Access Compliance Report

Public Rights-of-Way

(Curb Ramps)

Intersection ID: 28440	Main Street: DEARMON_RD	Cross Street: PROSPERITY_VILLAGE_DR	Location: NW
ADA ID: 606D85BFBB0B	Ramp Type: Perp	Initial Pass/Fail: Fail	Overall Compliance: No
Severity Score: 50			
Codes/Mitigation Info/Possible Solution		Field Measurements/Component Compliance

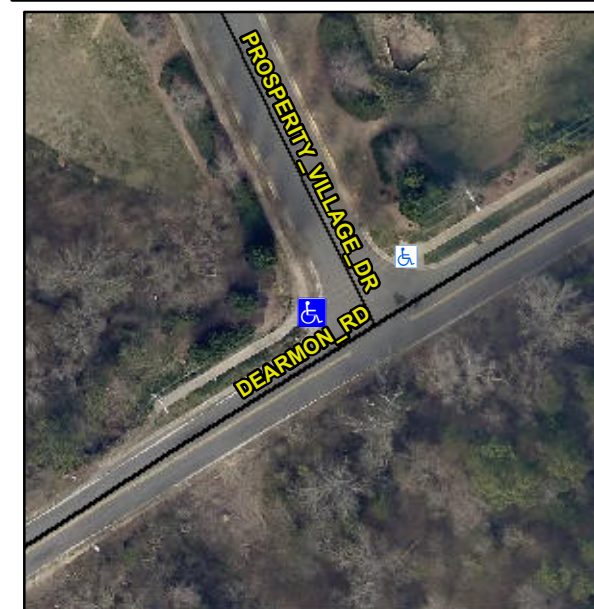
R304.2.2, R304.5.3

Compliance	Description	Data	Compliance	Description	Data
N/A	Ramp Length (in)	77.0	No	Ramp Slope (%)	20.0
Yes	Ramp Width (in)	50.0	No	Ramp XSlope (%)	11.1
N/A	Flare Type LT	N/A	N/A	Flare Type RT	N/A
N/A	Flare Slope LT (%)	N/A	N/A	Flare Slope RT (%)	N/A
N/A	Flare Traversable LT?	N/A	N/A	Flare Traversable RT?	N/A
N/A	Landing Length (in)	N/A	N/A	DWS Provided?	N/A
N/A	Landing Width (in)	N/A	N/A	DWS Contrast?	N/A
N/A	Landing Slope (%)	N/A	N/A	DWS Length (in)	N/A
N/A	Landing X Slope (%)	N/A	N/A	DWS Full Width?	N/A
N/A	Landing Curb? (Y/N)	N/A	N/A	DWS Offset (in)	N/A
N/A	Shared Landing?	N/A			
N/A	Gutter Ponding?	N/A	N/A	Gutter Slope (%)	N/A
N/A	Gutter Lip Ht (in)	N/A	N/A	Gutter X Slope (%)	N/A
N/A	Painted X Walk1?	No	N/A	Painted X Walk2?	N/A
	X Walk 1 Direction	To E		X Walk 2 Direction	N/A
N/A	X Walk 1 Width (in)	N/A	N/A	X Walk 2 Width (in)	N/A
	X Walk 1 Slope (%)	4.7		X Walk 2 Slope (%)	N/A
	X Walk 1 X Slope (%)	5.4		X Walk 2 X Slope (%)	N/A

Remove & Replace Entire Ramp.
